Davidson Drive Holdings, LLC
Town of Chester, Orange County, New York
Colliers Engineering & Design Project No. 23002650A

As requested, we have completed a preliminary review of the Site Plans prepared by Arden Consulting Engineers, PLLC revision dated January 17, 2023 and Traffic Impact Study prepared by Creighton Manning Engineering, LLP dated September 21, 2021 and revised January 18, 2023 (Revision #1) submission for the proposed Davidson Drive Holdings, LLC development. The proposal calls for the construction of a 166,024 sq. ft. light industrial/warehouse development on Davidson Drive immediately north of Lake Station Road just southwest of Bellevale Road (CR 82). Our review has focused on the methodology utilized, appropriateness of data and analysis results, as well as the adequacy of any recommended mitigation outlined for the project. We have also inspected the site and reviewed any proposed improvements to assist with the completion of our review. The following outlines the various areas reviewed and our preliminary findings and recommendations. Note that any outstanding items or other items that either need to be addressed or for the Board's consideration are identifie

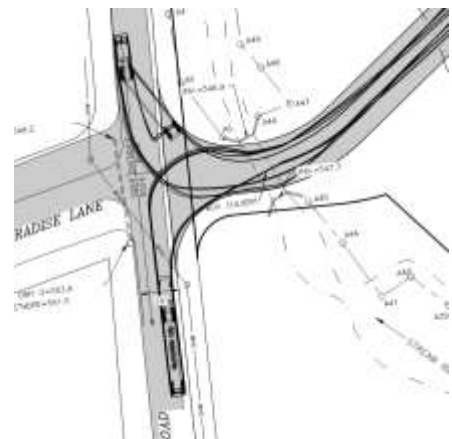
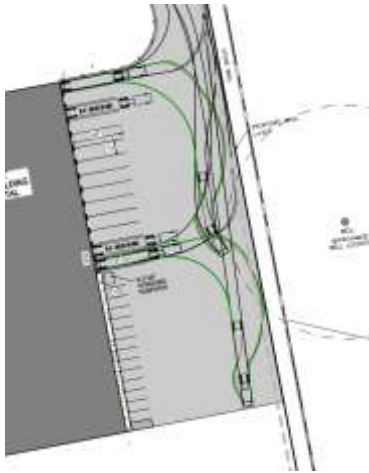
The Traffic Impact Study recommends the installation of modified warning signs along Kings Highway in the vicinity of Wickham Drive and Lake Station Road, which includes replacing the existing intersection ahead warning sign with a new offset intersection warning sign. No other offsite improvements are recommended as part of the Project.

20. The recommended signing changes are appropriate. Input should be provided by the OCDPW since Kings Highway is a County Road and the modification will require their review and approval.
21. Considering the anticipated additional traffic at the intersection of Kings Highway & Lake Station Road as a result of the Project, the installation of stop bar and double yellow centerline striping along Lake Station Road should be considered.
22. The installation of a stop bar along Lake Station Road at Bellevale Road should also be considered.
23. The pavement structure and physical condition of Town roadways should be addressed by the Applicant's engineers with the Highway Superintendent.
24. Input should be sought from both OCDPW and NYSDOT on this Project. Input from OCDPW is especially important given that primarily County roadways will be utilized for local access to the Project.

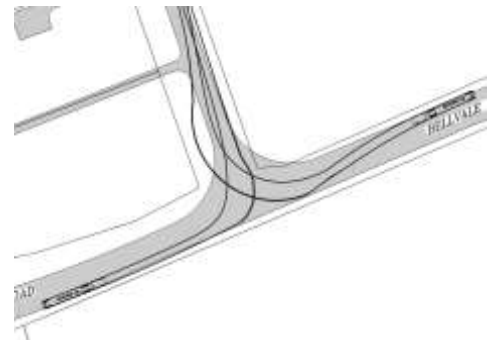
25. Plan Sheet 15 of 21 shows the WB-67 vehicle making a right turn out of the Site. The Traffic Study indicates all trucks will make a left turn out of the Site. This should be clarified.
26. The truck maneuvers at the Site access intersection (Sheet No. 15 of 21) appear to show that a truck turning into the site will not be able to make this maneuver at the same time that another vehicle is also exiting the site. Potential improvements should be identified by the Applicant's engineers and this should be reviewed further by the Board.

27. The truck turning maneuvers for trucks at the back of the building (Sheet No. 15 of 21) appear to indicate that trucks would be unable to back into or pull out of the truck spaces if a truck is already parked in the immediately adjacent spaces. This needs to be reviewed further as it may require some modifications to the building or paved area in this vicinity.
